Sizewell C Acoustic Fish Deterrent (AFD) Response to EDF Acoustic Fish Deterrent Report (EN010012-006229)

FGS Reference – 1688R0403

Figure 5.17 Depiction of SPs mounted on non-subsea piled beam structure

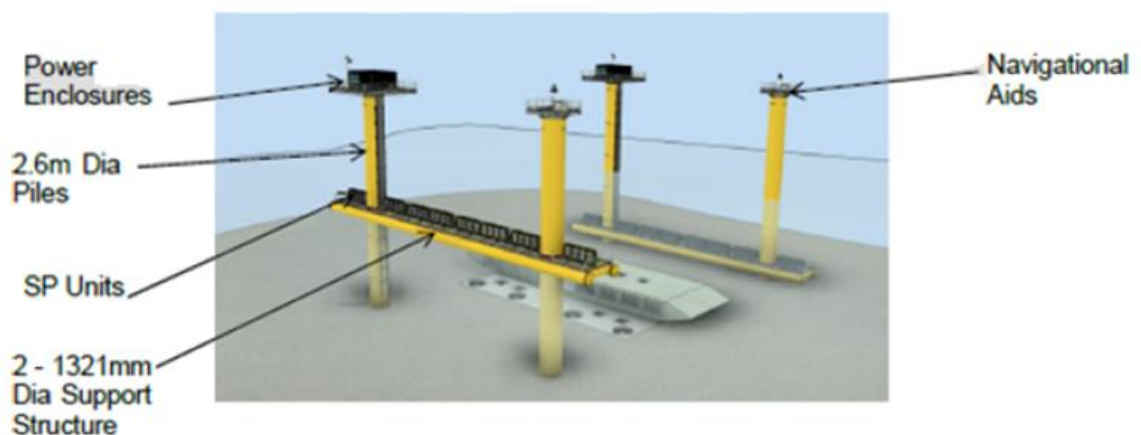
- The optioneering process for Hinkley concluded that the Sound Projectors should be deployed in frames that would be accessed by divers or an ROV.
- This was based upon the water depth and tidal variation at the site.
- Sizewell has significantly lower overall water depth, and significantly smaller tidal range.
- EDF states “the Sizewell C intakes locations are in a deeper depth (over the whole tidal cycle)”, however the mean depth is only 10m, so EDF’s statement is misleading.
- The conditions at Sizewell C open up other engineering options, such as deployment rails, which were discounted at Hinkley due to the large variations in tide at Hinkley.

One of the alternative deployment options considered at Hinkley Point C
